NASA Technical Memorandum 102012

Summary and Evaluation of the Strategic Defense Initiative Space Power Architecture Study

ABSTRACT

Mass Comparison (NPB)

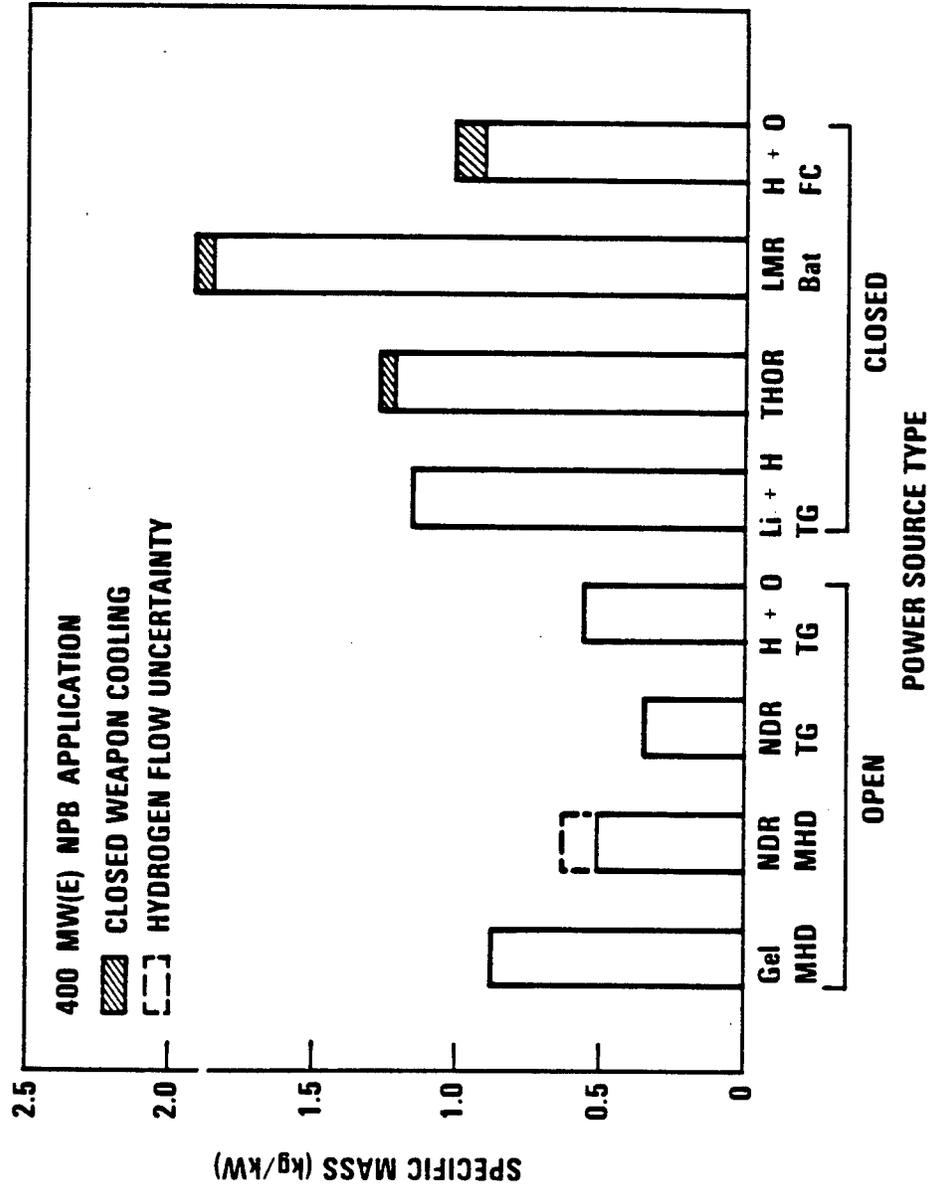
This chart was generated during Task 2 and has not been updated. The masses of several systems changed significantly during Task 3. GE will include an updated chart in their final report. Comparisons done elsewhere in this report do not use the values in this chart but have attempted to use GE's updated values.

***But When You Add Power Conditioning
(Based on TRW's PC Weight Estimates)***

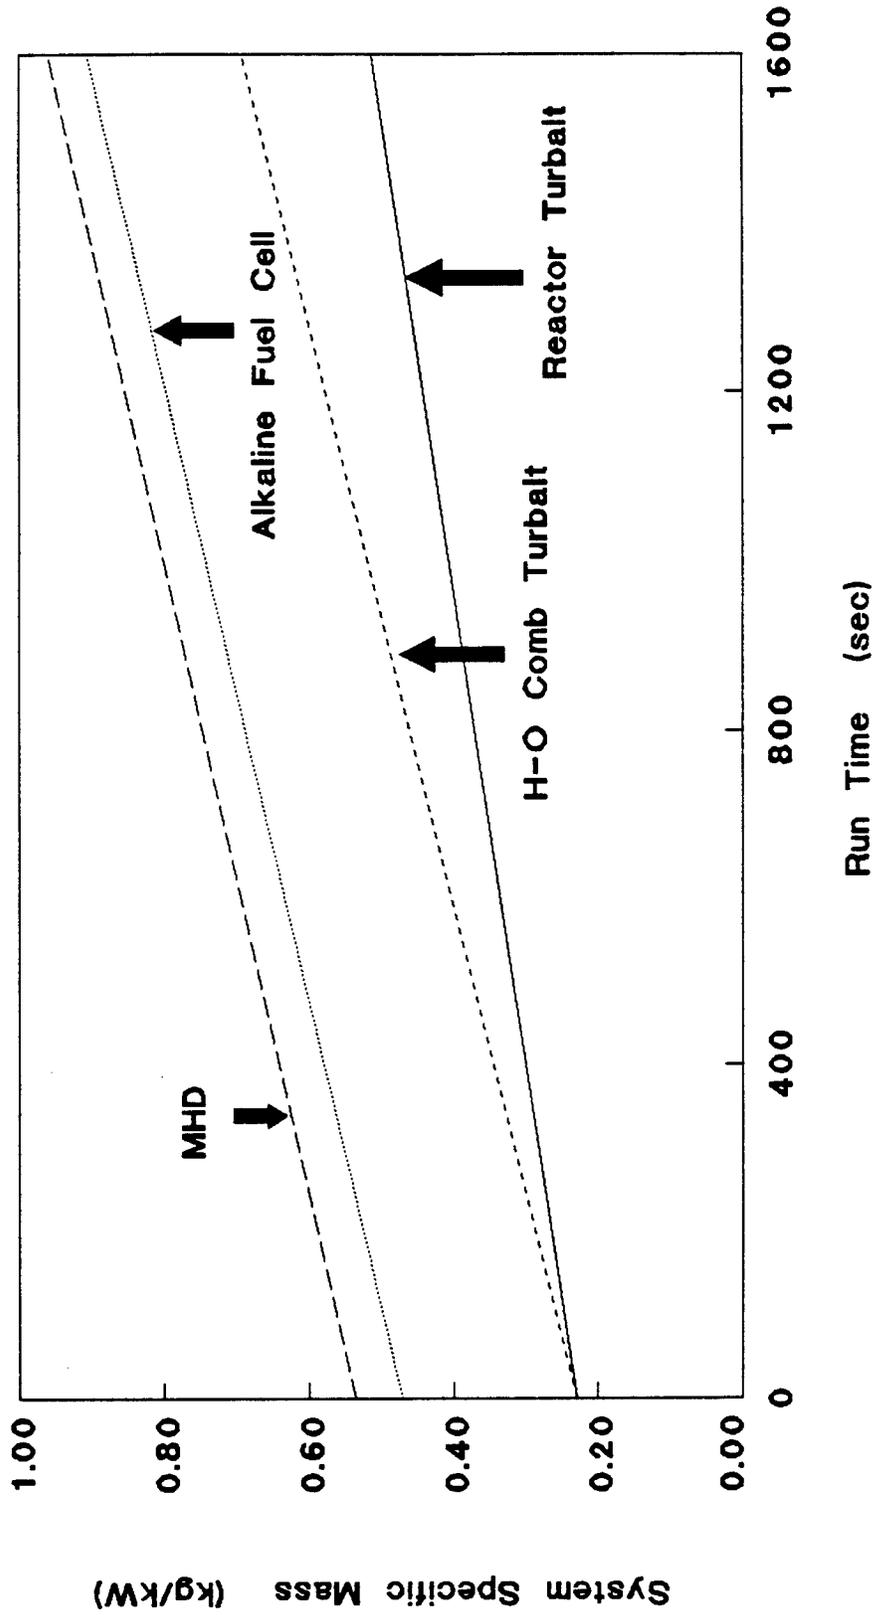
The previous chart did not include the weight of power conditioning. GE proposes the use of very light, cryocooled power conditioning equipment that would cause very little weight differences between the open power systems. On the other hand, Martin Marietta and TRW propose using very high voltage alternators so that heavy transformers are unnecessary to boost voltage to a value needed by klystron RF generators. Thus, they have lightweight power conditioning for turboalternator systems but not for low voltage systems such as MHD and fuel cells. In this chart we have added TRW's power conditioning weights (0.1 kg/kW for turboalternator systems and 0.4 kg/kW for low voltage systems) to the open power systems. Which of these last two charts applies depends on the success with developing high voltage alternators and/or lightweight, cryocooled power conditioning equipment. It also depends on whether the RF generators need high voltage for tube type RF generators (assumed in the facing chart) or low voltage for solid state RF generators.

Thus, the effects of power conditioning shown in the facing chart may be reversed for low voltage applications. But, for any application, power conditioning will probably be an important discriminator.

MM REACTOR-TURBOALTERNATOR POWER SYSTEM WEIGHT
ESTIMATE IS HIGHER THAN GE, TRW'S

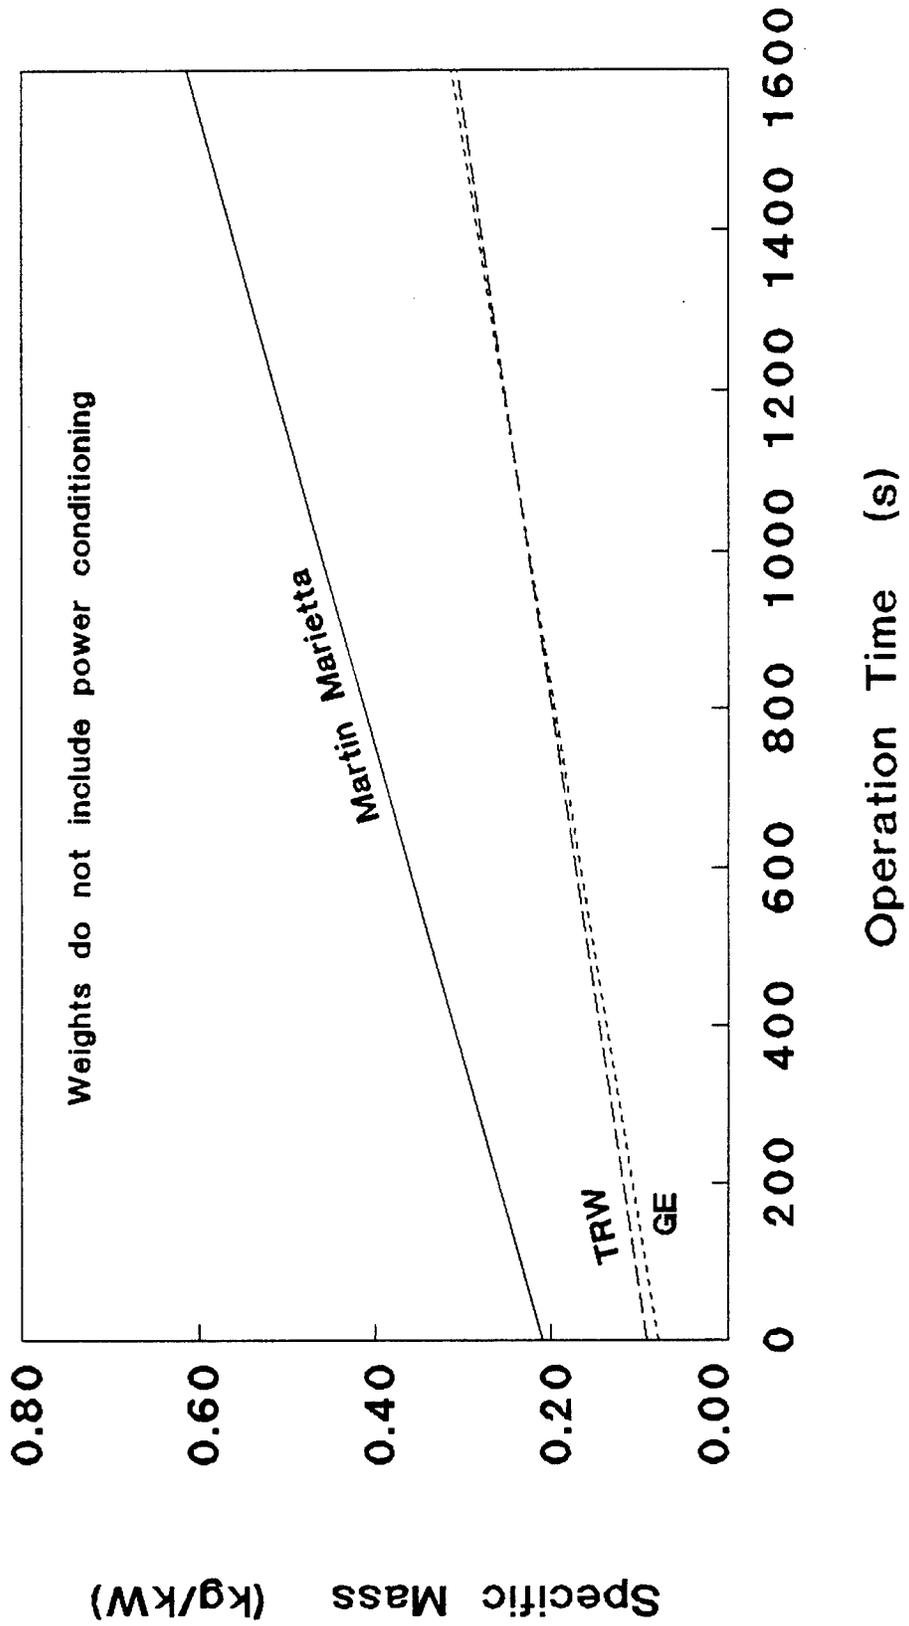
This chart compares the contractors' weight estimates for an open, burst mode, gas cooled reactor NPB power system that uses a turboalternator for power generation. Martin Marietta and TRW did not scale system mass with operation time. To find this scaling, we drew a line between their mass estimate at the design operation time and their mass estimates for a "dry" system (zero operation time). We normalized system mass by dividing by system power to remove differences due to different power levels. Martin Marietta's system is heavier than the other two. There are two reasons for this. Martin Marietta's generator is substantially heavier than either TRW's or GE's (see the following table), and they use twice as much hydrogen as the other two contractors. Martin Marietta also uses a very light tank which has no meteoroid protection, and this light tank tends to offset the greater quantity of hydrogen making their hydrogen mass penalty smaller than it should be.

MM ESTIMATED HIGHER COMBUSTION-TURBO-ALTERNATOR
SYSTEM WEIGHTS THAN GE OR TRW

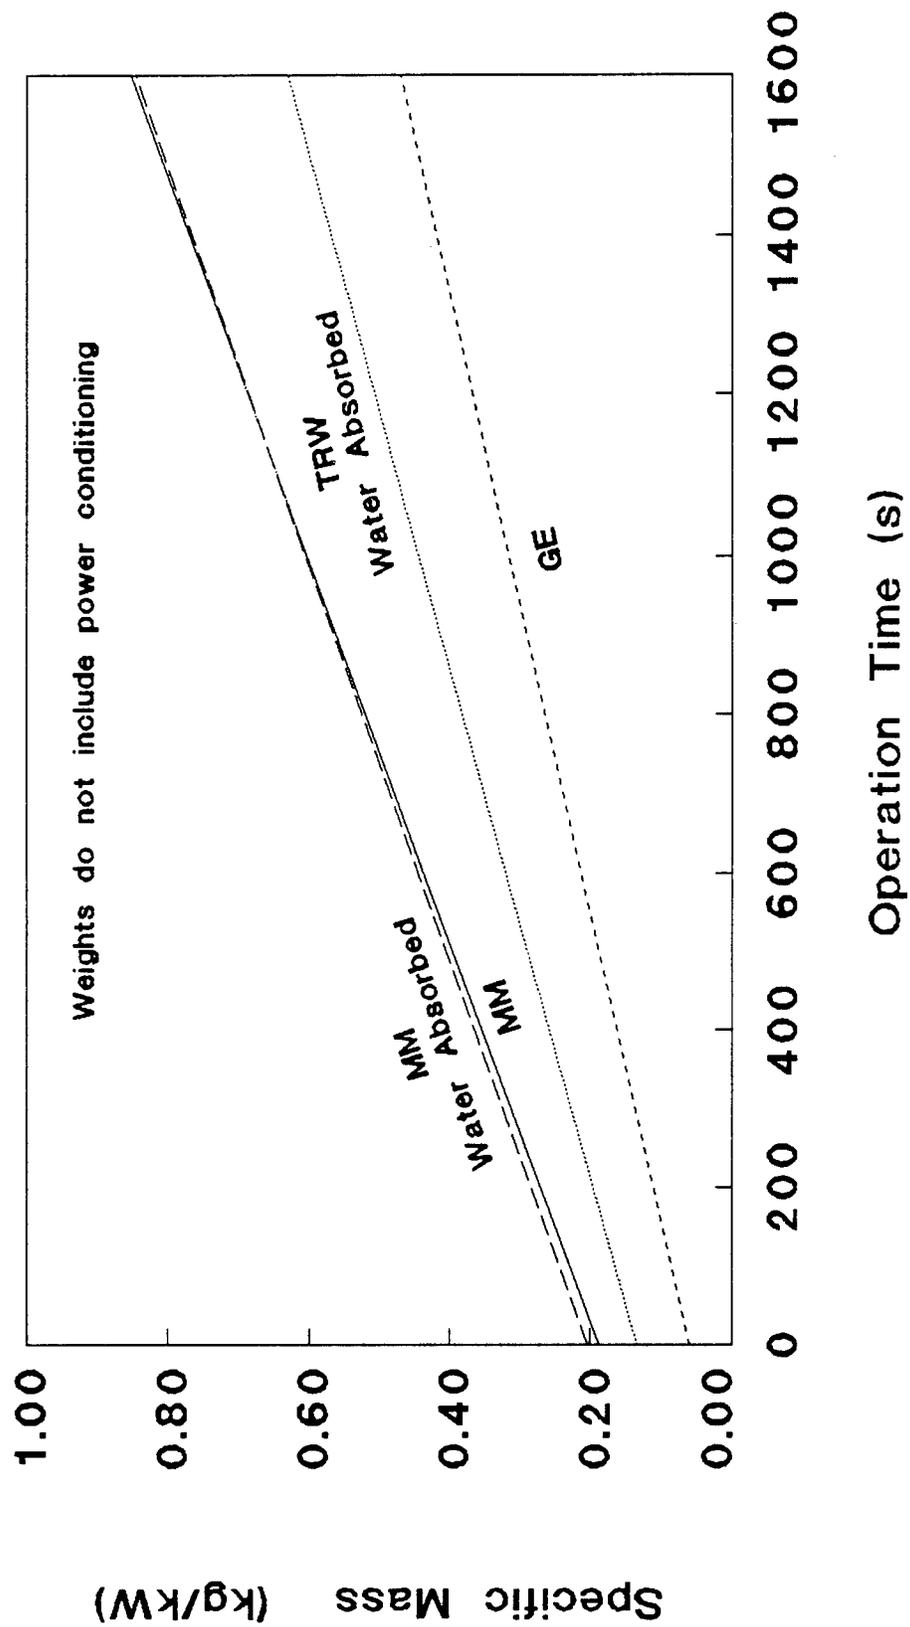
This chart compares hydrogen-oxygen combustion systems. The differences between the three contractors are the same as for the open reactor systems. The penalty associated with removing water from the power system exhaust is also shown here. Both TRW and Martin Marietta proposed designs for removing water from the power system's exhaust. TRW used a titanium reactor and Martin Marietta used a method proposed by Sundstrand. Sundstrand's method burns a stoichiometric mixture of hydrogen and oxygen to heat hydrogen in a combustion heat exchanger. The hydrogen leaving the heat exchanger is divided into two paths. The larger goes to the turbine, and the smaller supplies hydrogen for combustion. The combustion products are condensed by cold hydrogen in a heat exchanger and stored. Sundstrand's water removal equipment adds very little mass to the system as can be seen by comparing the two Martin Marietta curves. TRW's method is somewhat heavier as can be seen in the following table.

It appears that Martin Marietta's water absorbing system becomes slightly lighter than the non-absorbing system when operation time exceeds 1100 seconds. Their data indicates that the water absorbing system uses less oxygen than the other system, and this offsets the mass added by the combustor and heat exchangers needed by the water absorbing system when operation time exceeds 1100 sec. The water removal system comprises heat exchangers in the combustor and in the water condenser. Their weights depend on power level and not on run time; hence, the water removal equipment does not get heavier with increasing run time as one might expect. Since the oxygen saved does depend on run time, the slopes of the two curves are different. We have not estimated heat exchanger, combustor, or oxygen weights for the water absorbing system and cannot verify this conclusion. Recall that Martin Marietta did not scale with operation time; thus, they may not be aware of this result.

TRW's Brayton Cycle is not Optimum

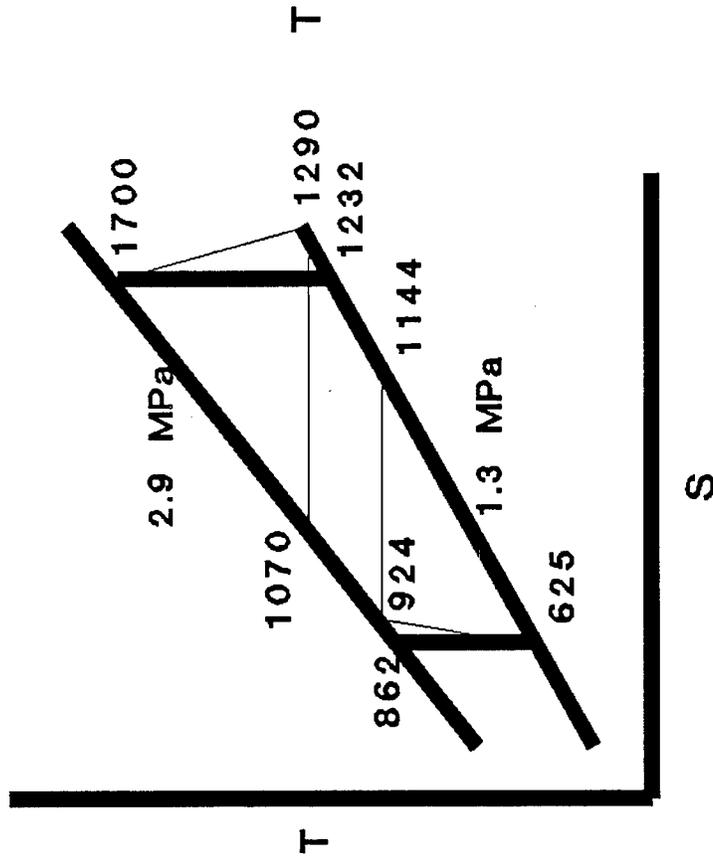
TRW Brayton--We tried to verify TRW's Brayton cycle efficiency and calculated 17.6 instead of 20 %. We also found a much more efficient cycle that requires dissipating half as much waste heat in the radiator. This cycle is shown on the chart following chart on the facing page. Their cycle has apparently not been optimized. We believe that the radiator is a little light for the same reasons stated in the paragraph above. We also notice that the power conditioning weight for the Brayton system is the same as for the thermionic system. This doesn't seem reasonable because the alternator in this system should generate a voltage (8.7 kV) higher than the converter's output voltage (7.5 kV), avoiding the need for a heavy transformer that was needed for the thermionic system converter. The two power conditioning weights should not be the same. It should be noted that power conversion weights for the Brayton system include redundant turbines and generators.

Martin Marietta- Impact Environment

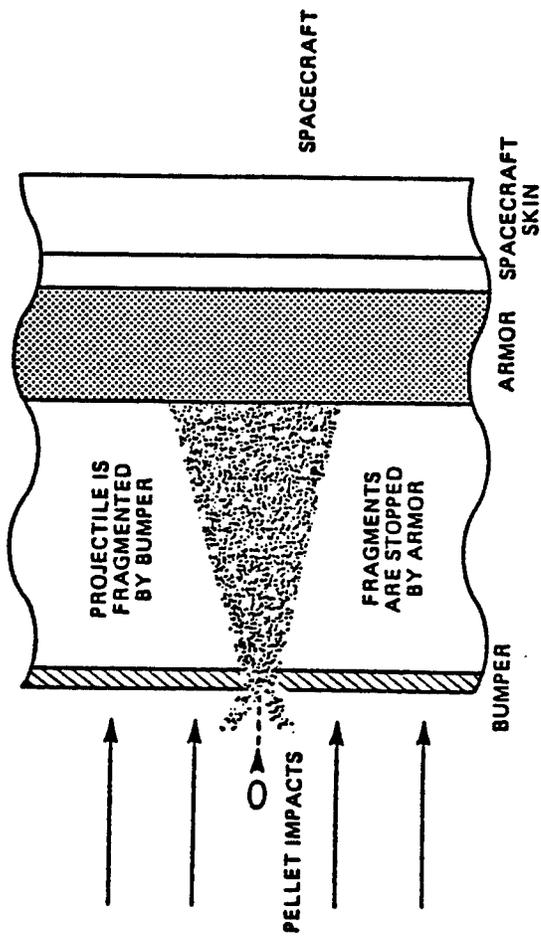
Martin Marietta discusses the debris/pellet environment but fails to mention the natural meteoroid environment. Their recommendations are to shun particle avoidance schemes due to the difficulty of the detection process, and to rely on passive shielding. They discuss a bumper/armor scheme which has proven effective against hypervelocity aluminum particles. They briefly mention that any shielding used will have a protective effect against a variety of environments and should be designed for the worst case.

TRW-NEUTRAL ENVIRONMENT

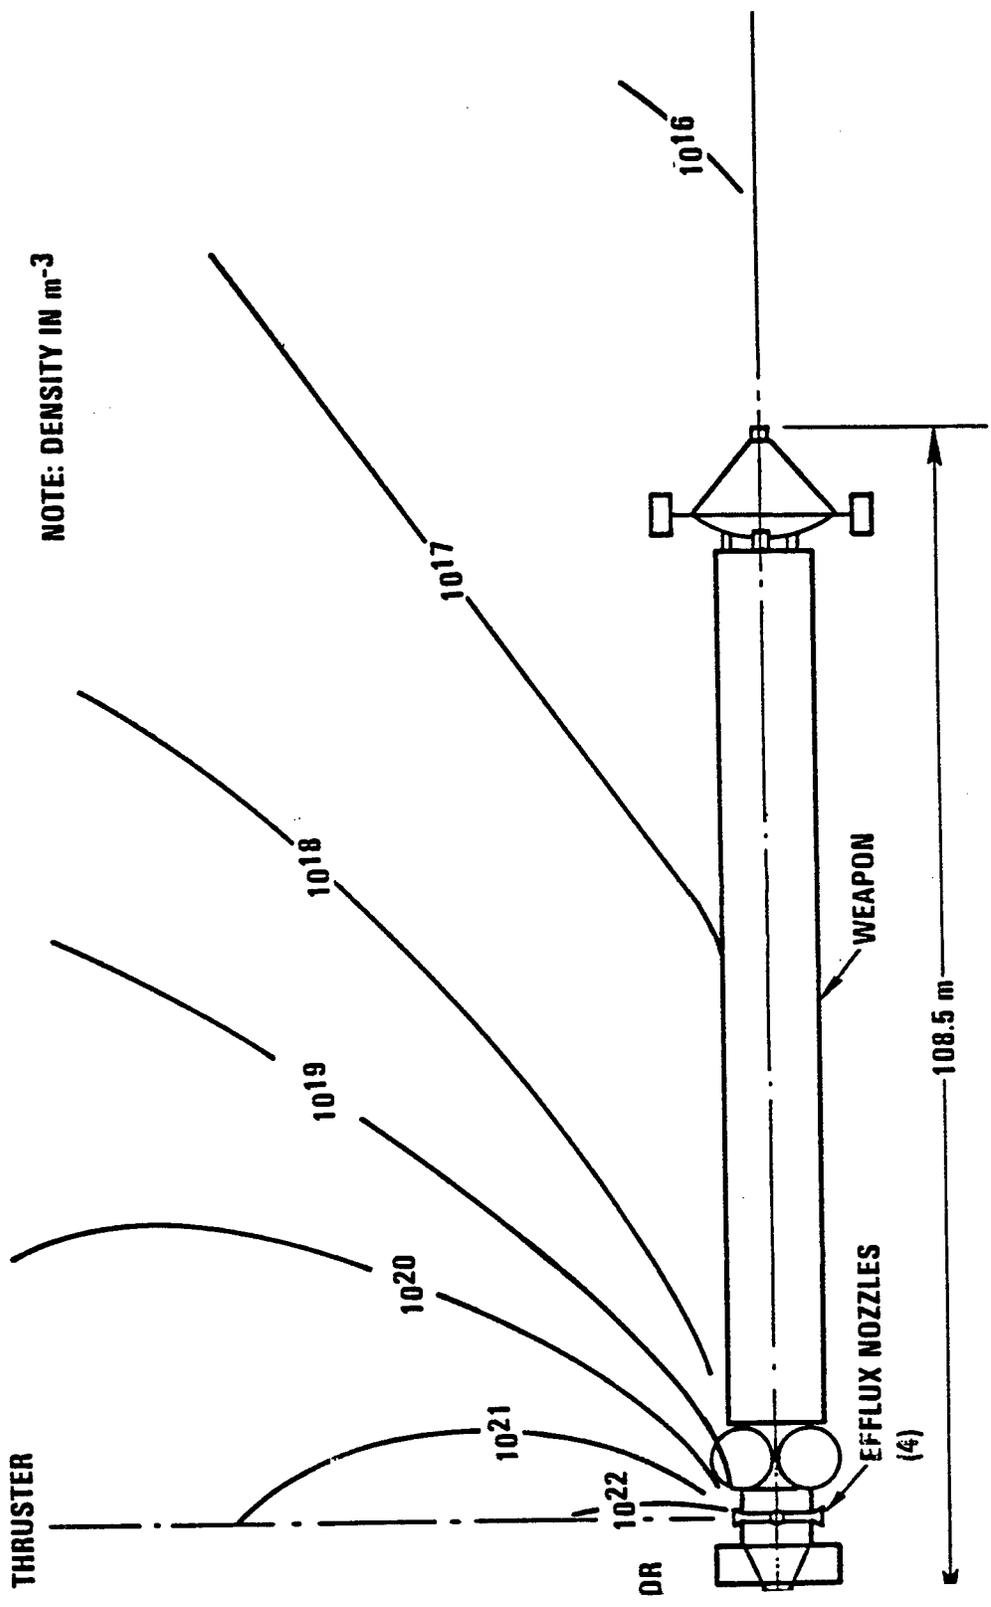
The only neutral environment treated is the effluent from open cycle systems. This was treated as part of Task 3, and the write-up in Task 4 repeats that in Task 3. The analysis is based on an assumption of four nozzles arranged for thrust cancellation, and used a numerical nozzle core flow plus external plume methodology. A more detailed analysis at a later design stage is recommended. TRW found that the effluent effects were within acceptable limits for the DEW and sensors considered, at least for the turbine generator system. The removal of H₂O is recommended for the GEL/MHD system. It is noted that the TRW design has constrained the high voltages to be within the spacecraft body, which in turn reduces the severity of the interactions of the effluent cloud with the system.
